Interactive comment on “Hydrogeomorphological analysis and modelling for a comprehensive understanding of flash-flood damaging processes: The 9th October 2018 event in North-eastern Mallorca” by Joan Estrany et al.

The response of the questions and comments provided by the anonymous RC1 referee will be addressed in a point by point format, being the comments from RC1 in bold.

RC1 - Anonymous Referee #1 Received and published: 18 December 2019

Fig. 1. Figure 1. Workflow of the experimental design.

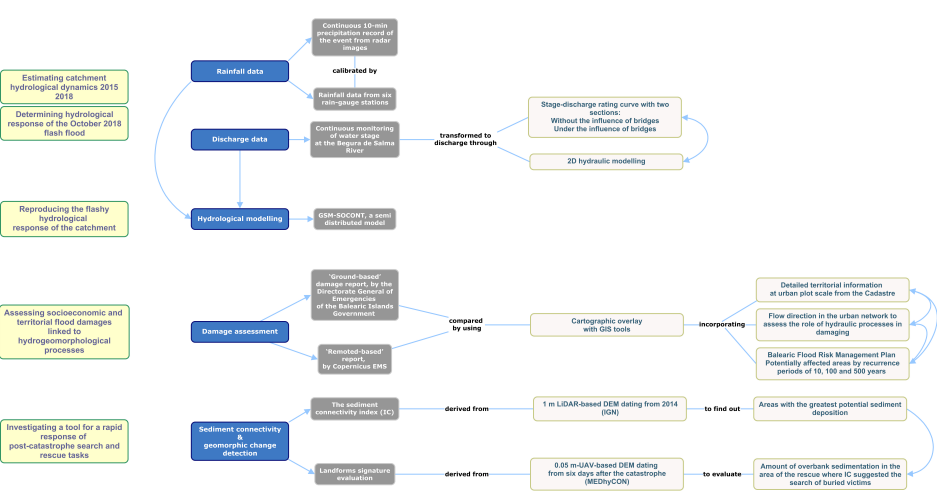
L109: since the structure of the paper is complex, a brief introduction to the next Sec-

tions could be useful

We believe that the specific objectives deployed in the last part of section 1. Introduction are providing the conceptual structure of the paper that is performed by the typical structure of sections in a scientific paper such as Materials and methods, Results and Discussion. In addition, the first paragraph of the section 2. Materials and Methods is really useful to provide a comprehension of the paper structure. It is true that the explanation provided in this first paragraph is in terms of methods, but they are completely related with the structure of the paper. However, to provide more consistence to the structure, we have completed this first paragraph of the section 2. Materials and methods, as follows (Lines 122-124 of the new MS version): “Finally, high-resolution digital elevation models (HR-DEM) were generated by LiDAR 2014 data from the Spanish National Geographic Institute and by imagery captured through a low-cost UAV just six days after the catastrophe to calculate a sediment connectivity index (IC) and measure geomorphic changes (Fig. 1)”. In addition, we have designed and performed a new figure with a workflow of the different steps and their relation to the objectives of the manuscript. This is the new Figure 1, captioned as “Methodological workflow of the research study”.
